Well Name: DIAMONDBACK 25 FEDERAL COM	Well Location: T19S / R32E / SEC 25 / SESE / 32.6267226 / -103.7133116	County or Parish/State: LEA / NM
Well Number: 01	Type of Well: CONVENTIONAL GAS WELL	Allottee or Tribe Name:
Lease Number: NMNM12413	Unit or CA Name: 1 DIAMONDBACK 25 FEDERAL	Unit or CA Number: NMNM103138
US Well Number: 3002534679	Operator: EARTHSTONE OPERATING LLC

Type of Submission: Notice of Intent      Type of Action: Plug and Abandonment

**Permanent Abandonment of Federal Wells  
Conditions of Approval (LPC Habitat)**

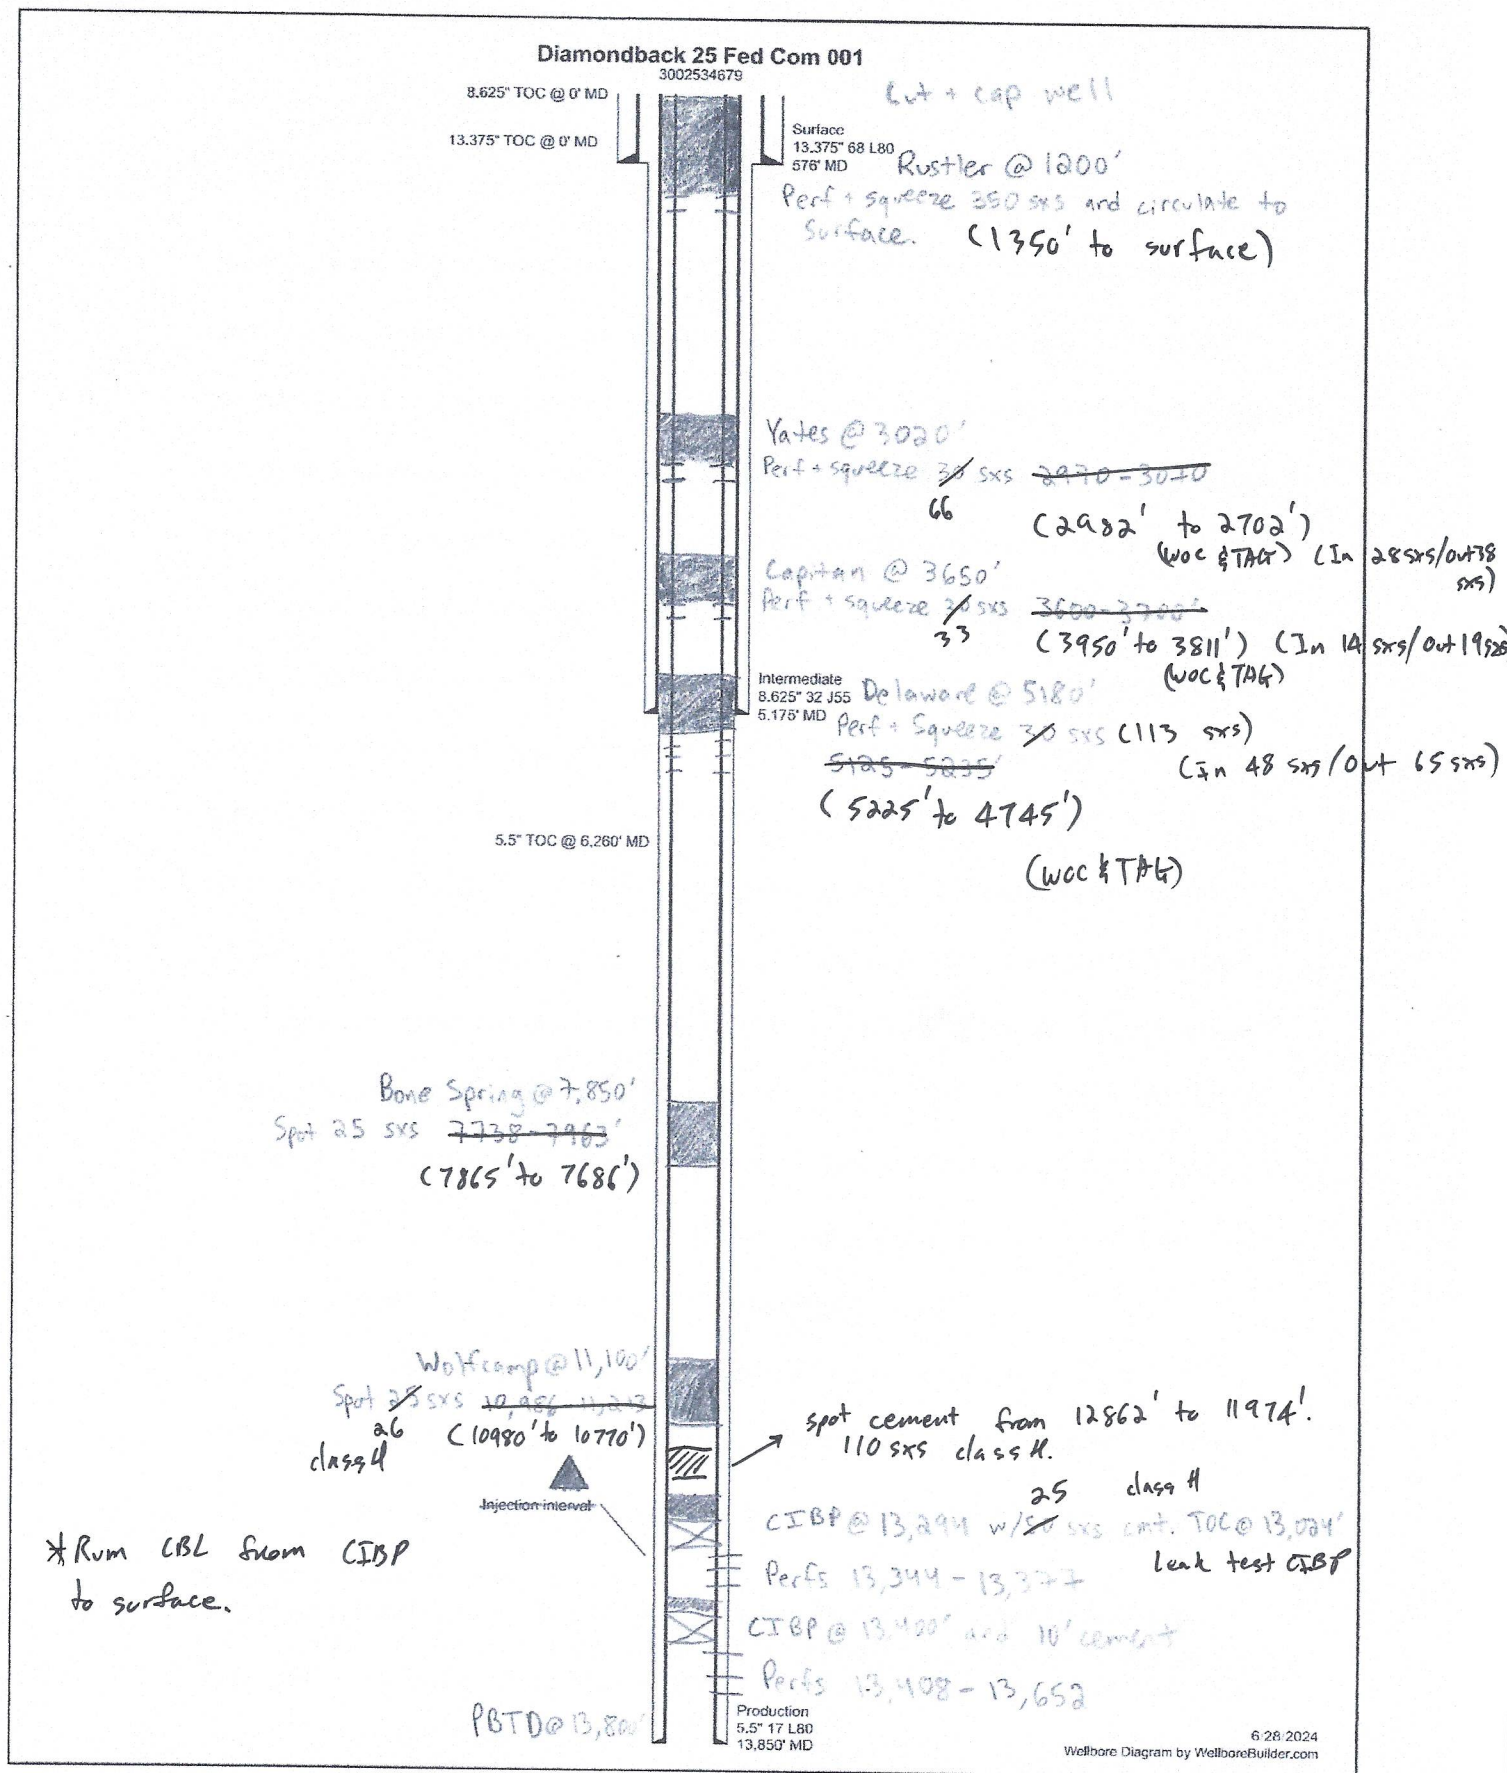
\* Run CIBP from CIBP to surface.

Second CIBP @ 13294' with 50' sx class H cmt, EST TOC @ 13024' 25 sxs class H (Leak test CIBP)

Spot CMT Plug from 10986' - 11219' with 25 sx class H cmt (10980' to 10770') 26 sxs

Spot CMT Plug from 7736' - 7963' with 25 sx class H cmt Tag TOC for verification (7865' to 7696')

Spot Cmt Plug from 5425' - 5235' with 30' sx class C cmt (Perf and Sqz from 5225' to 4745') WOC &amp; TAG (In 48 sxs/Out 65 sxs)

Perf &amp; Sqz @ 3650' Spot 30' sx class C cmt plug from 3600' - 3700' wait 4 hours Tag TOC for verification (3950' to 3811') (In 14 sxs/Out 19 sxs)

Perf &amp; Sqz @ 3020' Spot 30' sx class C cmt plug from 2970' - 3070' wait 4 hours Tag TOC for verification (2982' to 2702') (In 28 sxs/38 sxs Out)

Spot cement from 12862' to 11974'. (110 sxs class H).
